# TS Casual Wear Limited

24 November 2024

## 1. Building Information

## 2. Observation

Undesignated storage on 5<sup>th</sup> floor

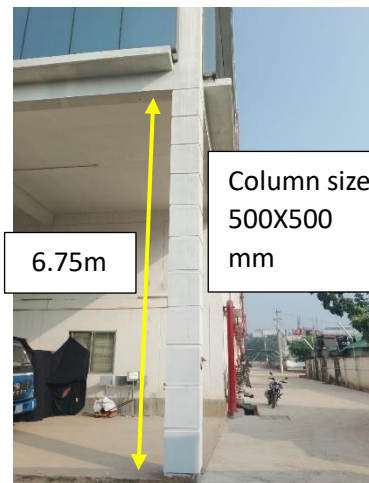
**Observation 2:** The load plan doesn't comply with BNBC (Main Production Building).

**Description:** Live load for storage is considered as 5 kPa. Also, undocumented storage was found on 4<sup>th</sup> and 5<sup>th</sup> floor. The building engineer is required to update the load plan for the storage area in compliance with BNBC.

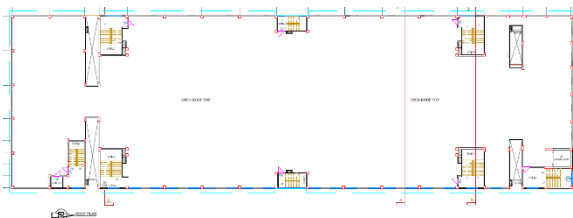
**Observation 3:** The column appears to be slender (Main Production Building).

**Description:** The column appears to be slender due to heigh unsupported length. The building engineer is required to check the column for slenderness ratio and incorporate it in the design report.

**Observation-10:** Discrepancy in as-built drawing (Security room & RMS room, Utility Building-1, Utility Building-2).

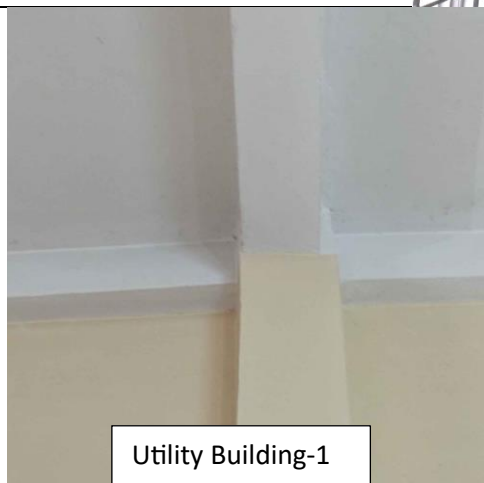
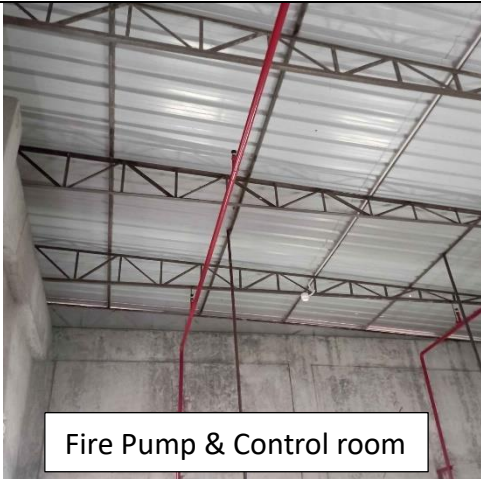
**Description:** Column C-1 was found as 250mmX300mm instead of 450mmX450mm in the Security room & RMS room. The dimension of the beam was found 250 (w)X375(d) instead of 300(w)X450(d) in (Utility Building-1, Utility Building-2).

Retrofitting drawing

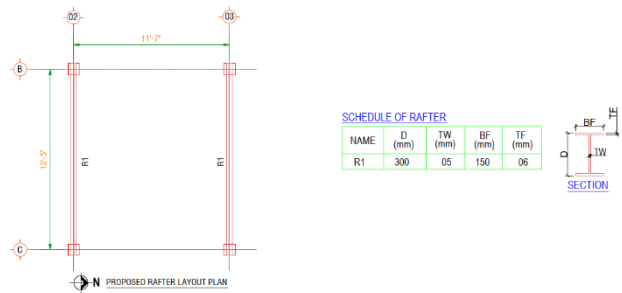
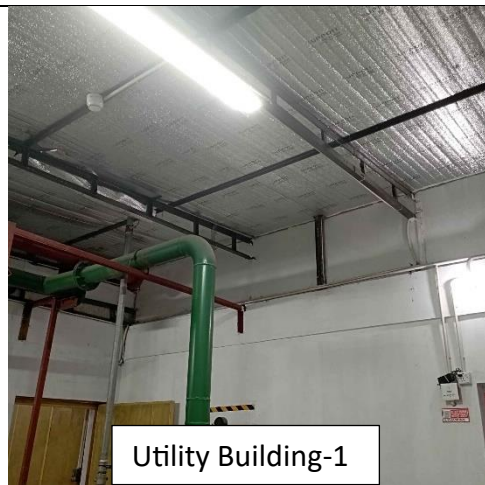
**Observation-11:** Retrofitting work not carried out (Utility Building-1, Fire Pump & Control room, Maintenance Room).

**Description:** The retrofitting drawing was available for these structures but retrofitting work was not carried out. The building engineer is required to submit the retrofitting scheme to RSC for review. Implement it after getting acceptance from RSC.

**Observation-13:** Corrosion on roof sheet (Security Restroom).

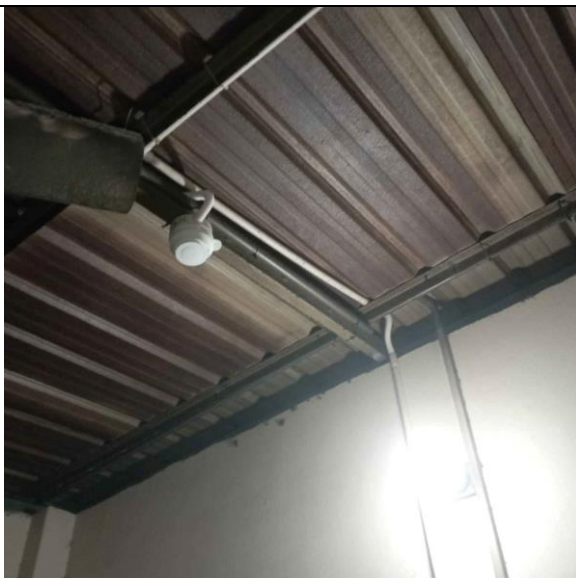
**Description:** Corrosion was found on the roof sheet. The building engineer is required to provide rust-proof paint on steel members and roof sheets to prevent corrosion.
